## *LIGO Laboratory / LIGO Scientific Collaboration*

LIGO - T040172-00-D

### LOS Output Electronics Modifications

R. Adhikari, P. Fritschel

**Figure 1** Modeled transfer functions of the analog ETM filters.

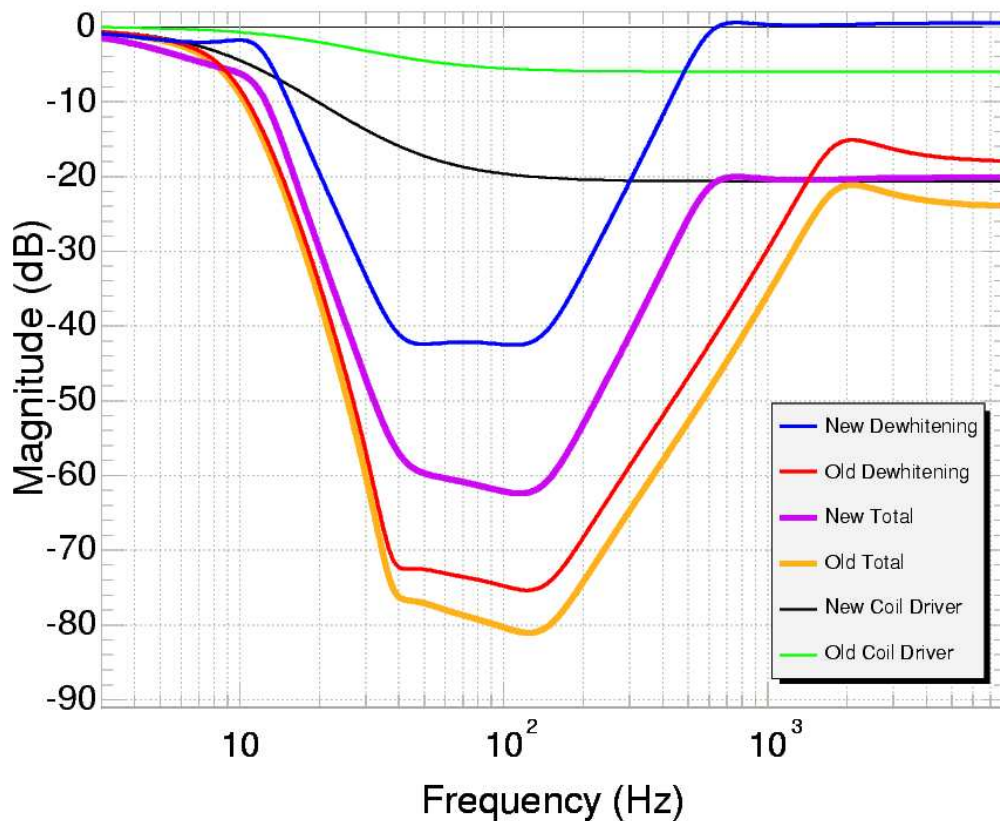
Figure 1 & 2 show only the shape of the filter; we are also proposing going from a DC gain of 3 in the dewhitening board to a DC gain of 1.

**Figure 3** Increased dynamic range as a function of frequency: Ratio of the total attenuation of the new post-DAC filtering to the old.

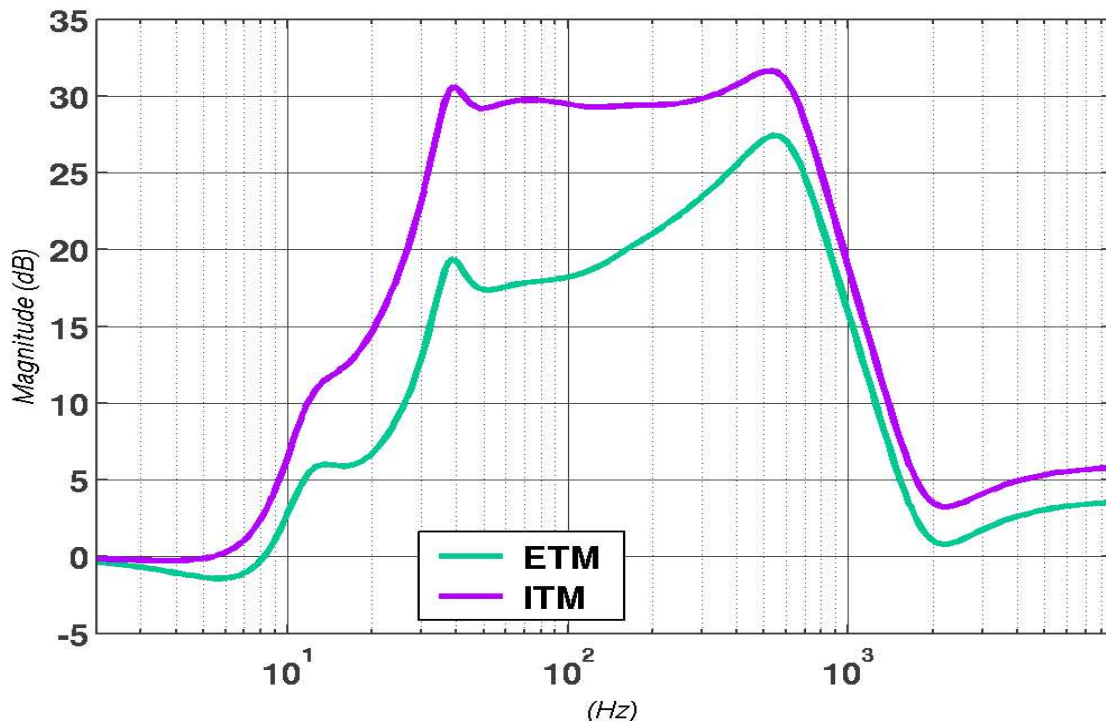
Another motivation for these modifications is to recover some of dynamic range lost through overfiltering the DAC noise from 10-1000 Hz. As shown in figures 1 & 2, there is less overall post-DAC attenuation with the new filtering. The next plot shows the calculated effect of this on the ITM & ETM control signals for the Hanford 4km.

**Figure 4 Top:** H1 ETM Coil Driver (as installed)

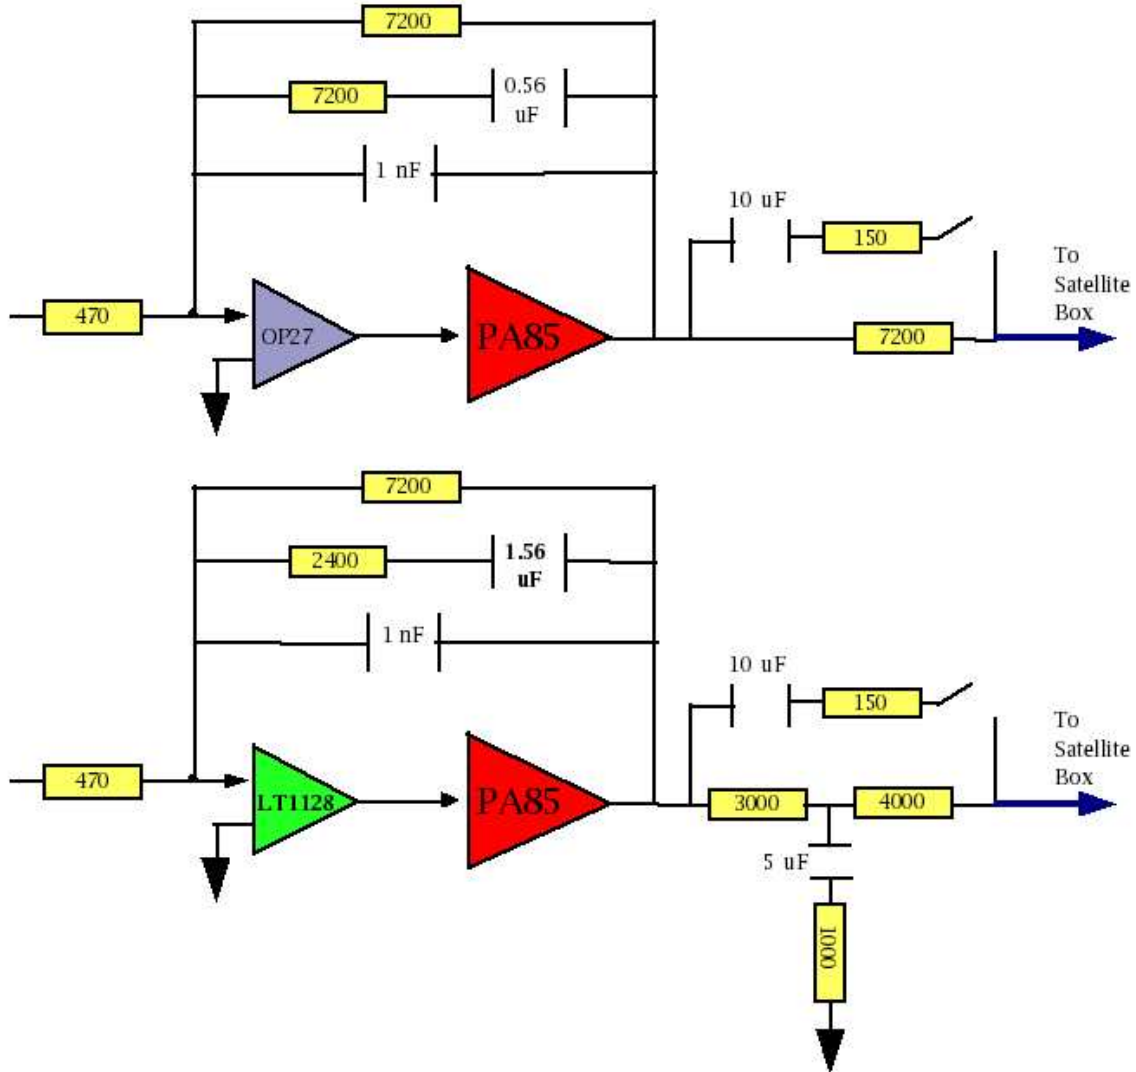
There are two pieces to the coil driver modification:

- 2X more GW band filtering in the feedback stage around the PA85; the 20:40 Hz pole:zero filter goes to a 10.6:42.5 Hz pole:zero.
- A new, passive R-C-R filter (11.7:31.8 pole:zero) after the PA85 to passively filter out noise without reducing the voltage swing required for lock acquisition.

The proposal is to change the ETM Coil Drivers only, since the ITM circuits are not used for lock acquisition and already have a 4:32 pole:zero filter in the feedback stage. As shown in Section 7, the noise from ITM Coil Driver will not dominate the noise.

**Bottom:** Proposed new configuration
